Specific Design Plan Parkside

SDP-1302-06

SUBJECT: Specific Design Plan SDP-1302-06

Parkside, Sections 5 and 6 Architecture

ARCHITECTURE, HUDSON & MADISON

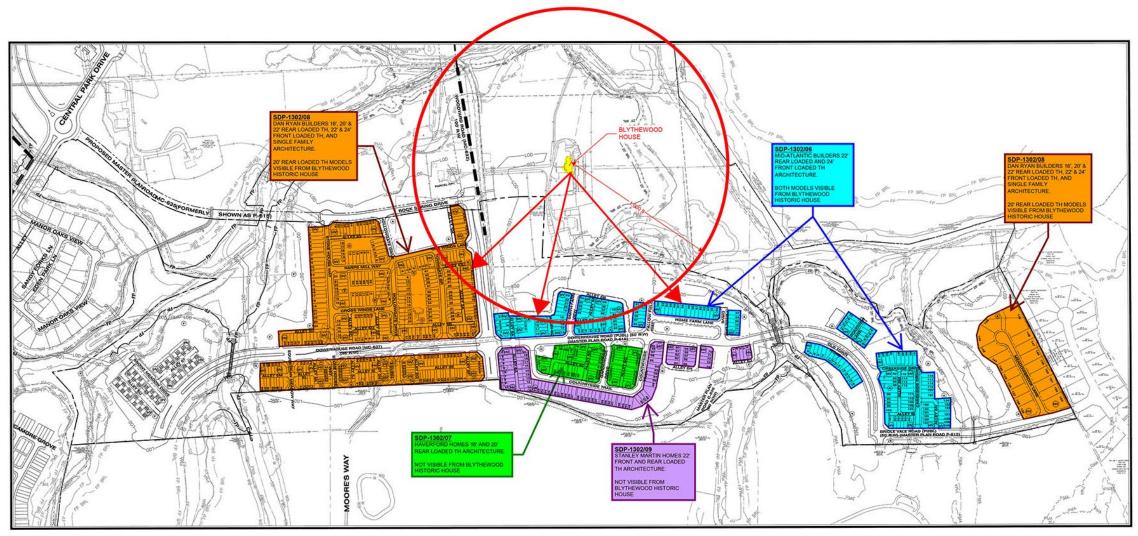
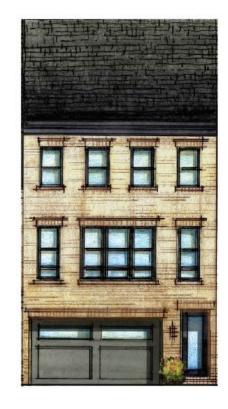
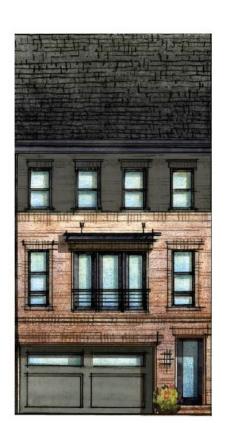
The proposed house types range in size from a base finished area of 2,605 to 3,013 square feet. The units feature a gabled roof line, high-quality detailing such as brick accents above and below the windows, and front entries defined with brick rows or columns. The proposed front façades offer optional finishes including vinyl siding, brick, stone, and cement board siding, with shutters, specialty windows, metal railings, and/or front porches. However, staff recommends that additional architectural features such as dormers or reverse gables be added to the front elevations to break up the mass of the roofline, provide architectural interest, and be consistent with other architectural models used in other sections of in Parkside. Various other conditions regarding percentage of brick, garage doors, and roofline features have been conditioned herein to maintain consistency with Sections 1, 2, and 3 of Parkside, and within this section.

architectural elevations submitted with this application show the scale, mass, proportion, and material of the buildings and have been found acceptable. It is noted that these units will be substantially screened from the Blythewood Historic Site by the proposed landscape buffer, and high-quality materials will be used on the buildings that are potentially most visible.

- e. Include a brick/masonry front façade tracking chart for the single-family attached lots on the plan set.
- f. Revise the rear-load garage doors to match the design of the front-load garage doors in terms of paneling and windows.
